Access Compliance Report

Public Rights-of-Way

(Curb Ramps)

Intersection ID: 30340	Main Street: DULIN_CREEK_BV	Cross Street: FOX_SWAMP_RD	Location: SE
ADA ID: F988AFA2B9B6	Ramp Type: PerpDiag	Initial Pass/Fail: Pass	Overall Compliance: No
Severity Score: 0			
Codes/Mitigation Info/Possible Solution		Field Measurements/Component Compliance

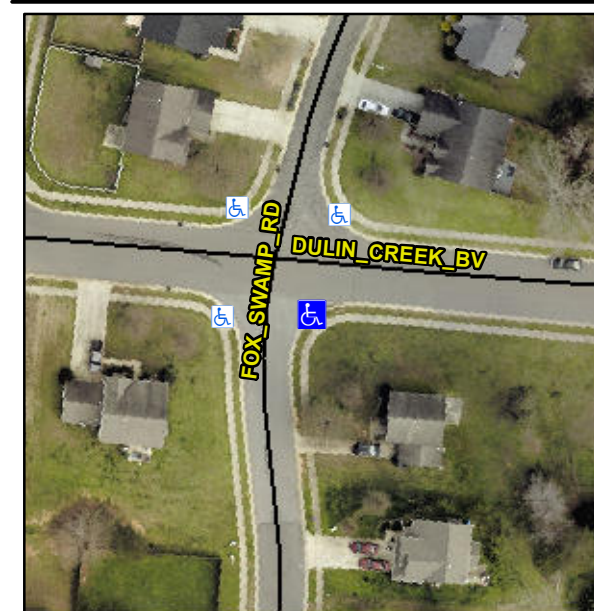
Not Found, R304.2.1, R304.5.3, R305.2

Remove & Replace Curb Ramp With Two New Directional Ramps or Equivalent.
